City of Portland, Maine – Building or Use Permit Application 389 Congress Street, 04101, Tel: (207) 874-8703, FAX: 874-8716

Location of Construction: 78 Madeline St		Owner: Chris Chedler		Phone: 774-9000		Permit No: 990836
Owner Address: 78 Madeline St Portland		Lessee/Buyer's Name:		Phone:		
Contractor Name: ***Thomas Soulier		Address: Rte 1, Scarborough		Phone: call 450 0930		Permit Issued: AUG 9 1999
Past Use: 1-Family		Proposed Use: Same		BusinessName:		
Proposed Project Description: *** Construct Addition		COST OF WORK: \$ 24,000		PERMIT FEE: \$ 168.00		Zone: CBL: 150-C-10
		FIRE DEPT. <input type="checkbox"/> Approved <input type="checkbox"/> Denied		INSPECTION: Use Group: R3 Type: 512 300996 Signature: [Signature]		
PEDESTRIAN ACTIVITIES DISTRICT (P.A.D.)		Action: Approved <input type="checkbox"/>		Signature: _____		Zoning Approval: Special Zone or Reviews: <input type="checkbox"/> Shoreland <input type="checkbox"/> Wetland <input type="checkbox"/> Flood Zone <input type="checkbox"/> Subdivision <input type="checkbox"/> Site Plan maj <input type="checkbox"/> minor <input type="checkbox"/> mm <input type="checkbox"/>

BUILDING PERMIT REPORT

DATE: 6 Aug 99 ADDRESS: 78 Madeli

ROOF FRAMING

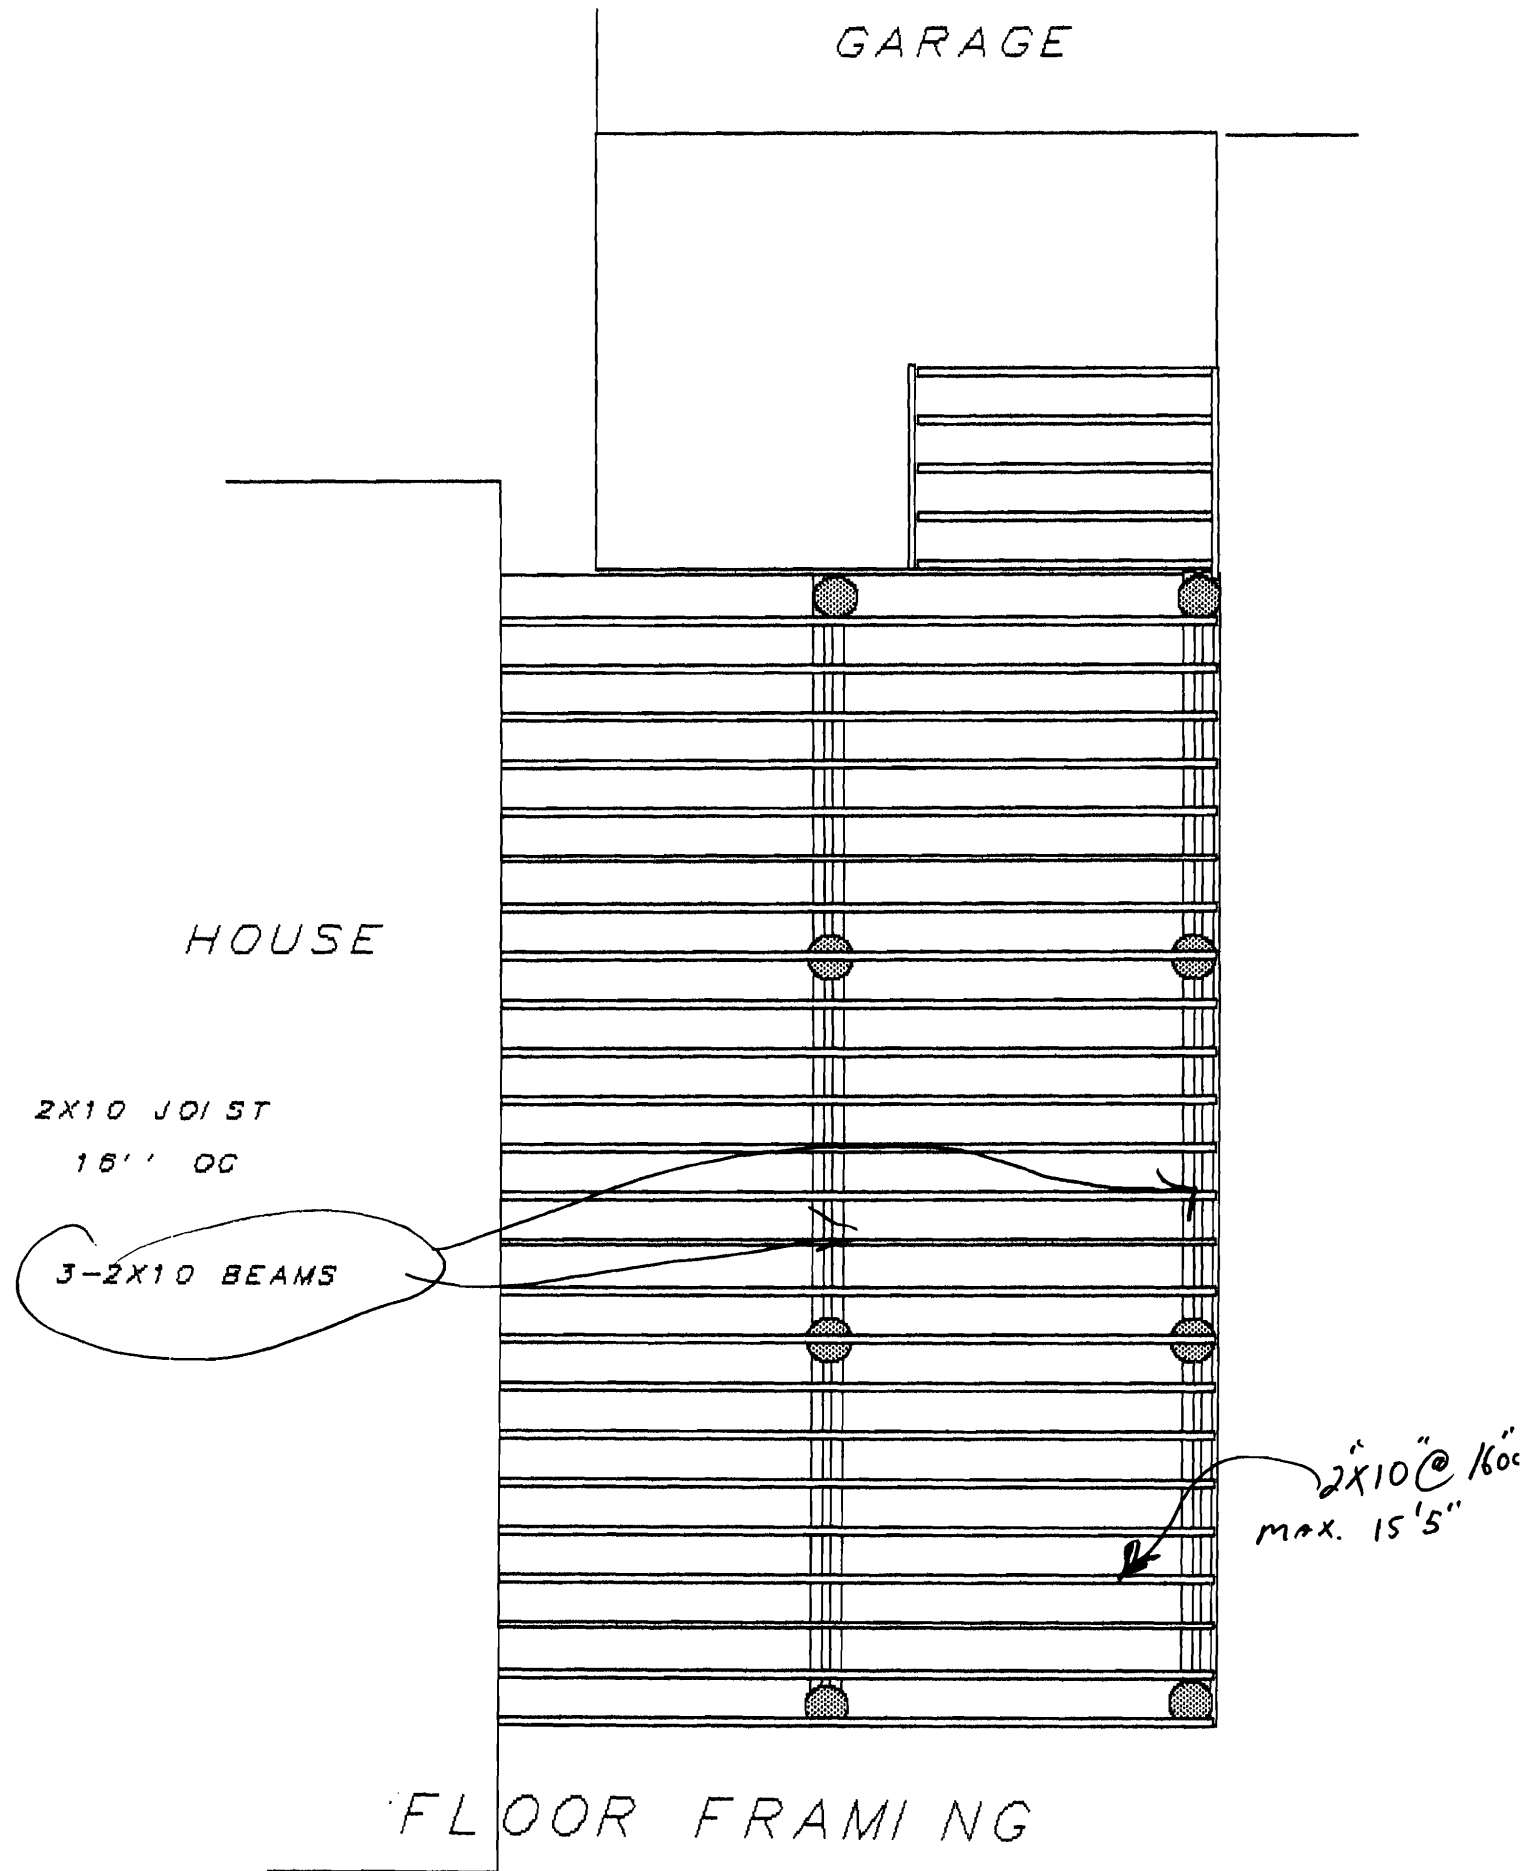
MAX. SPAN 2"X6" rafters
@ 16" O.C. IS 10'8"

MAX. SPAN
2"X6" rafters
@ 16" O.C.
IS 10'8"

FLOOR FRAMING

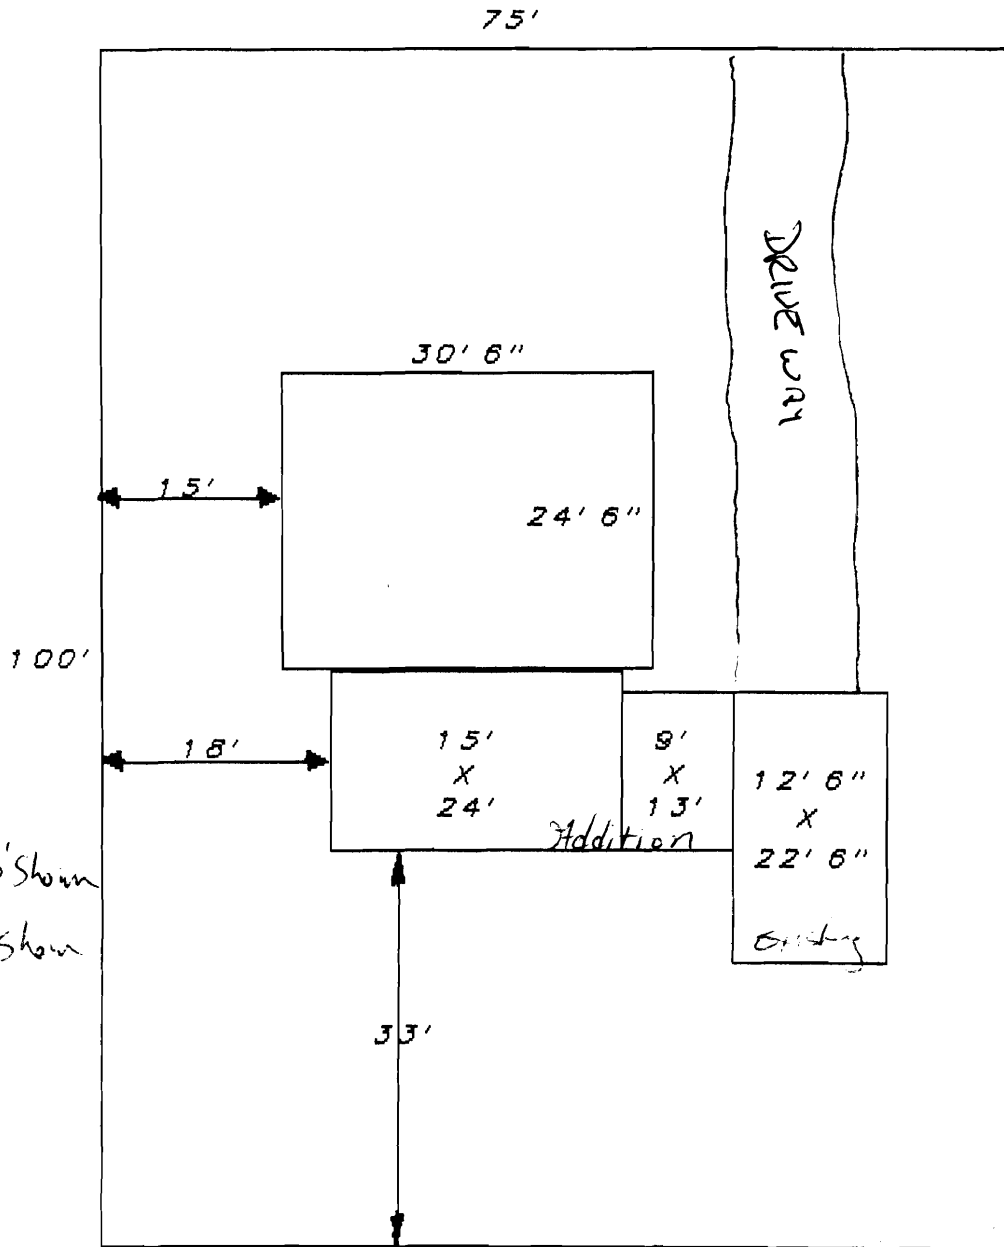
2X10 @ 16"
max. 15'5"

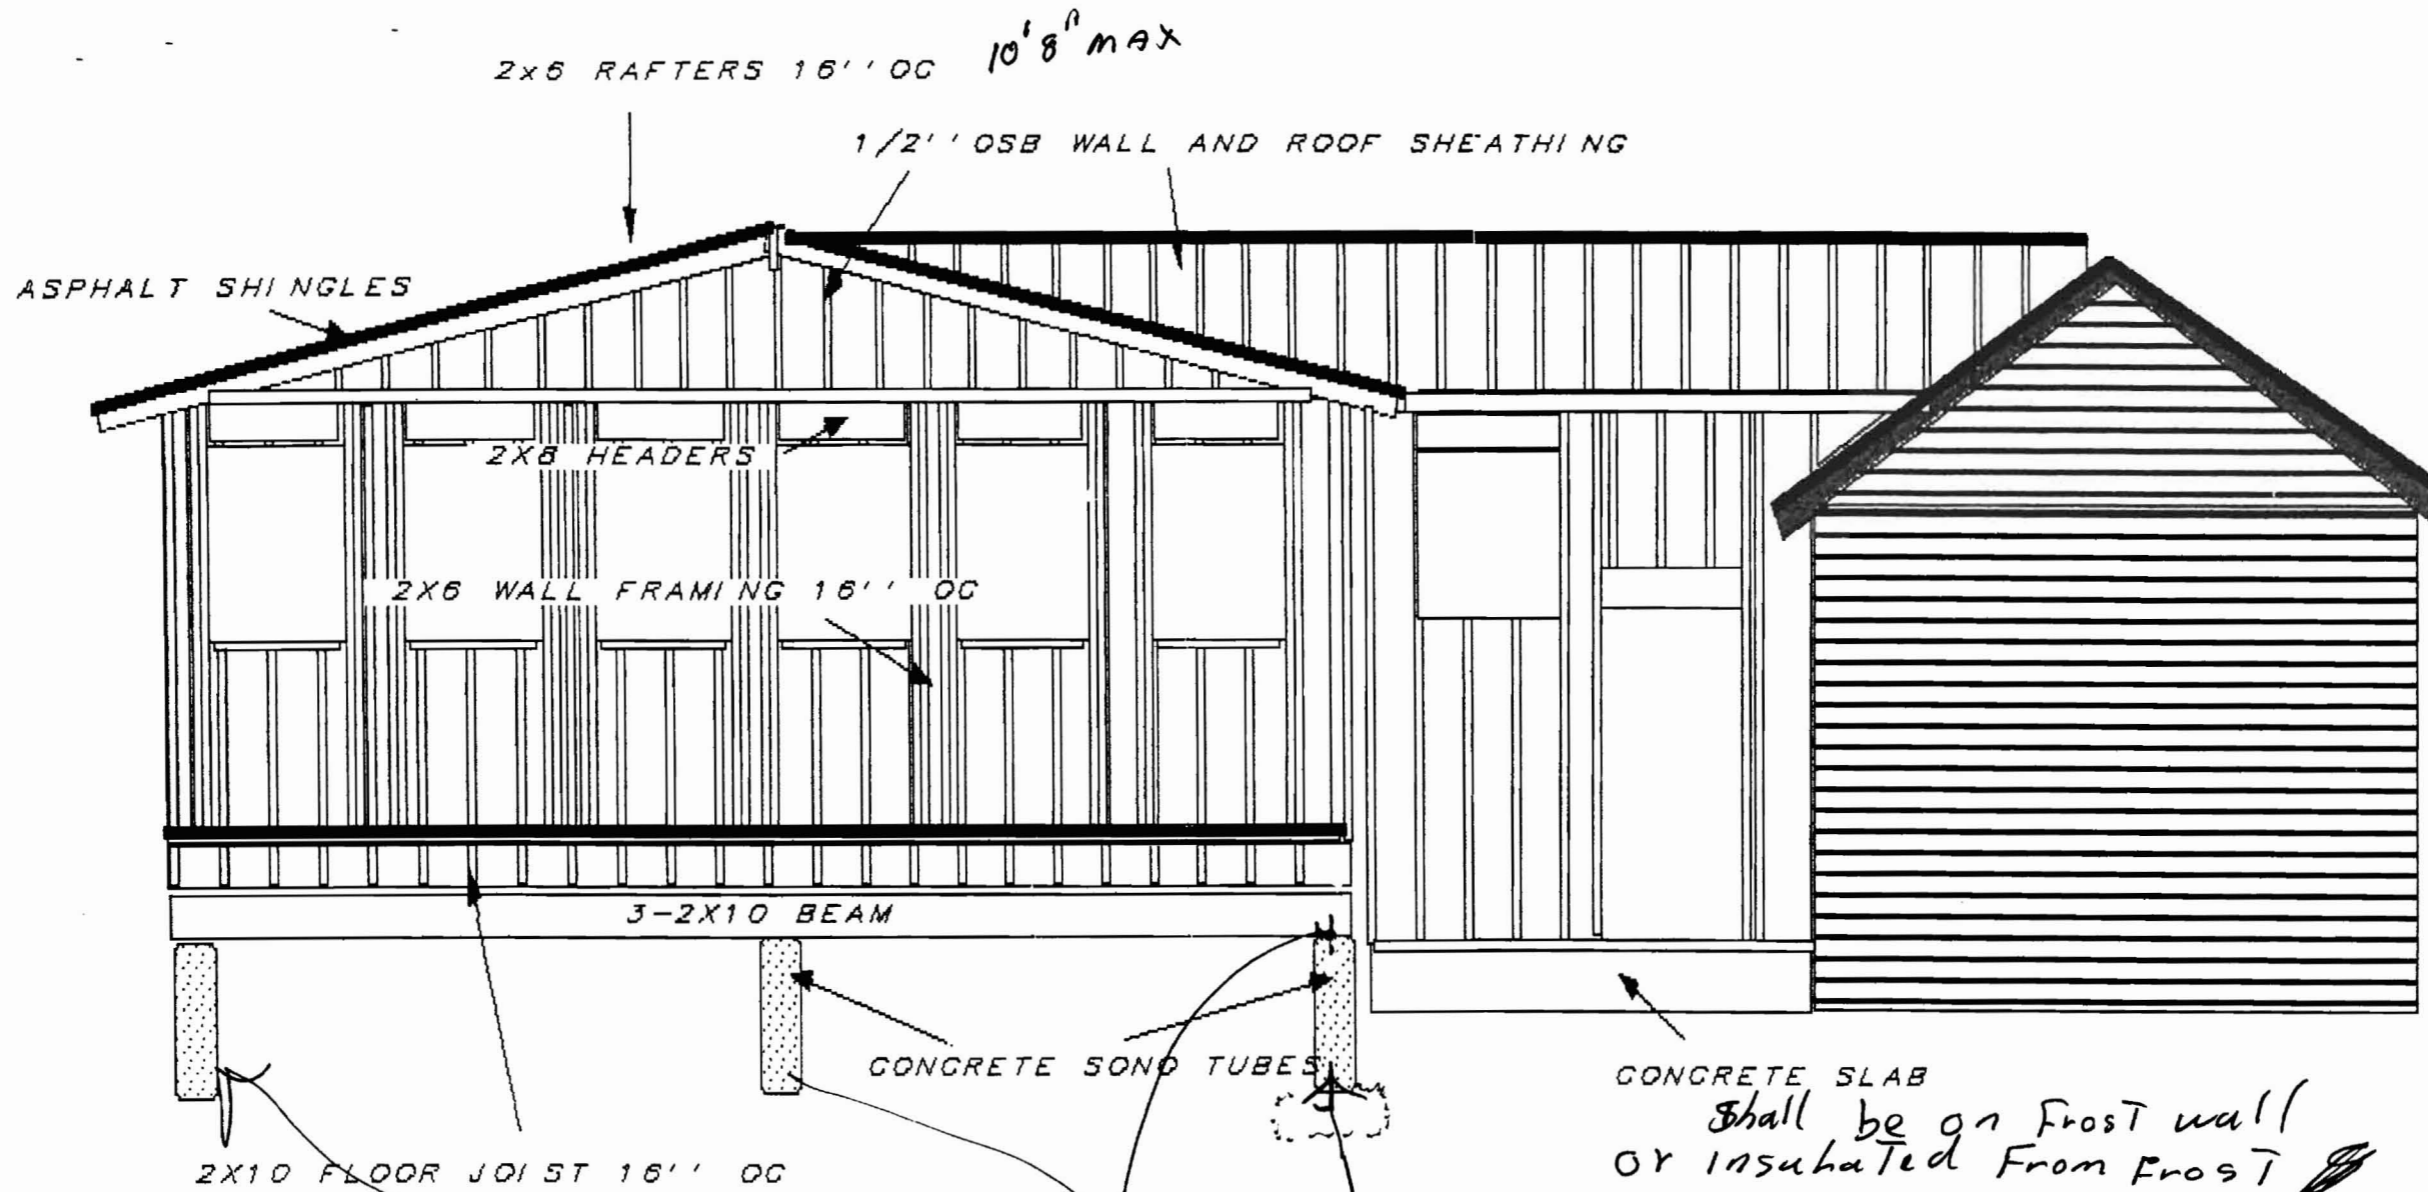
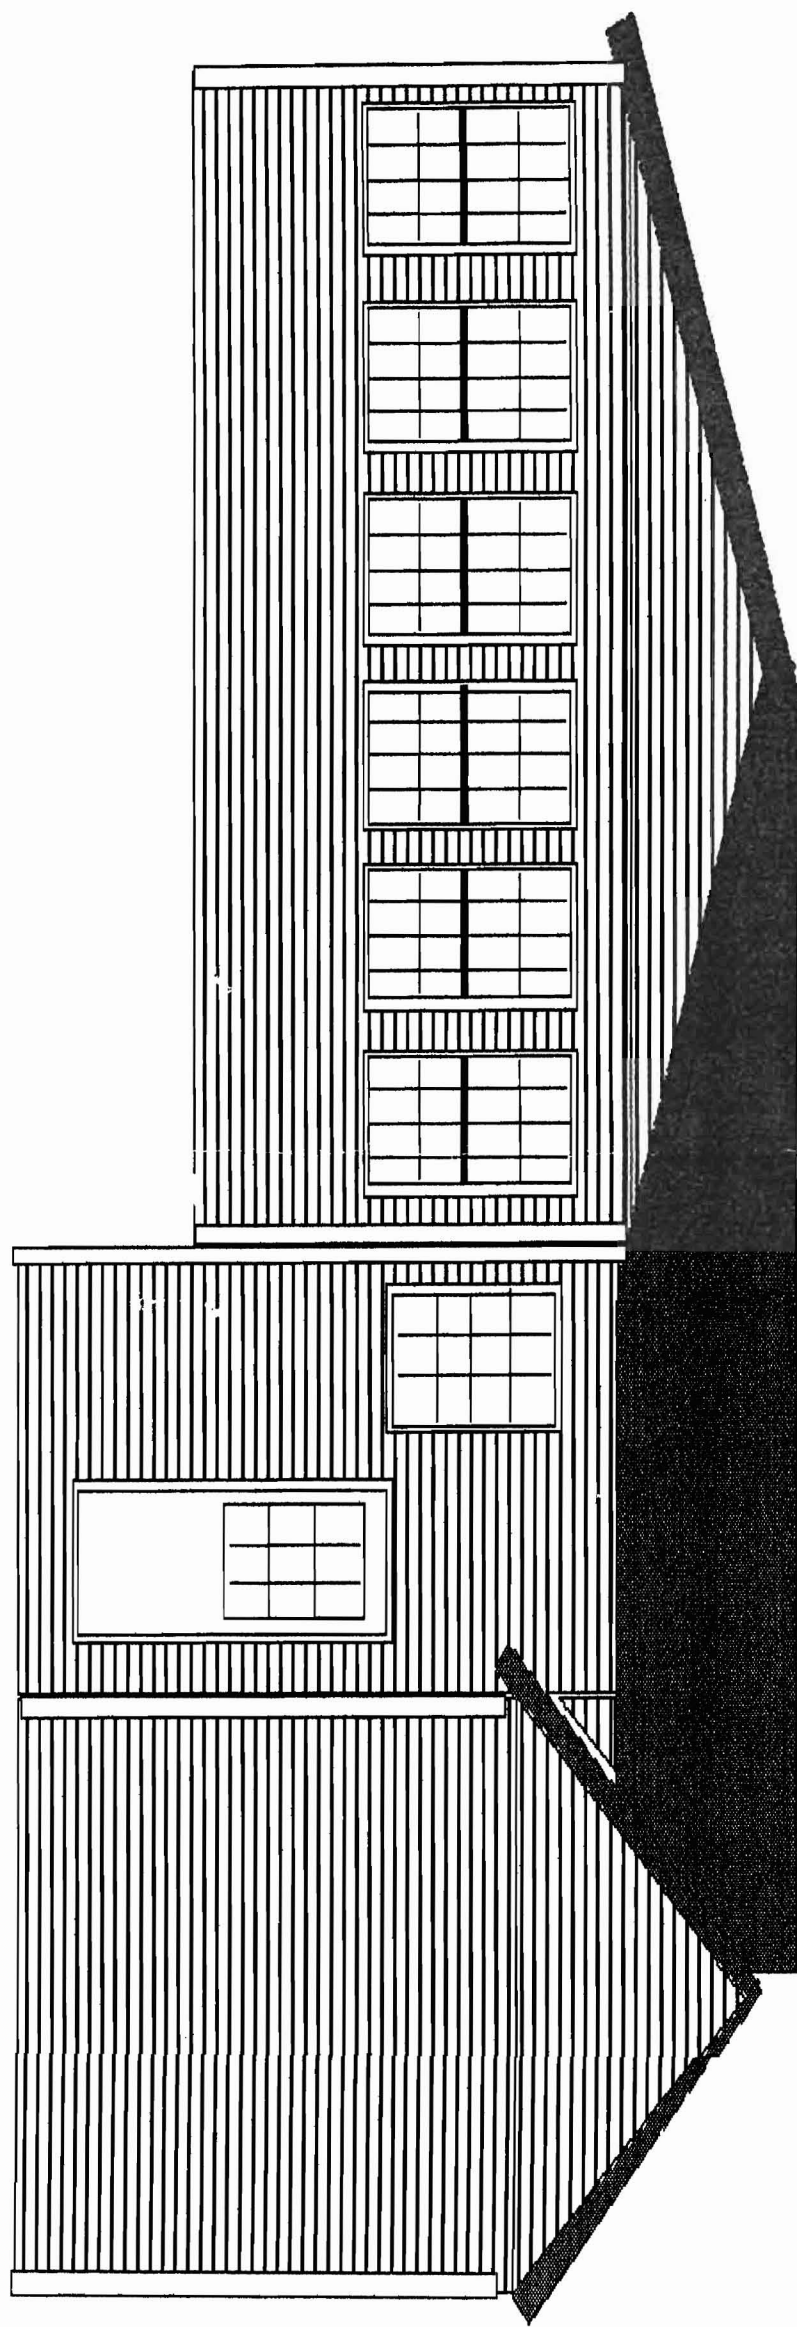
Fasterer
between pier
and Framing

Piers shall be
Placed on Footings 16x12 min.
with anchor connecting the
Footing and pier - 4' below grade.
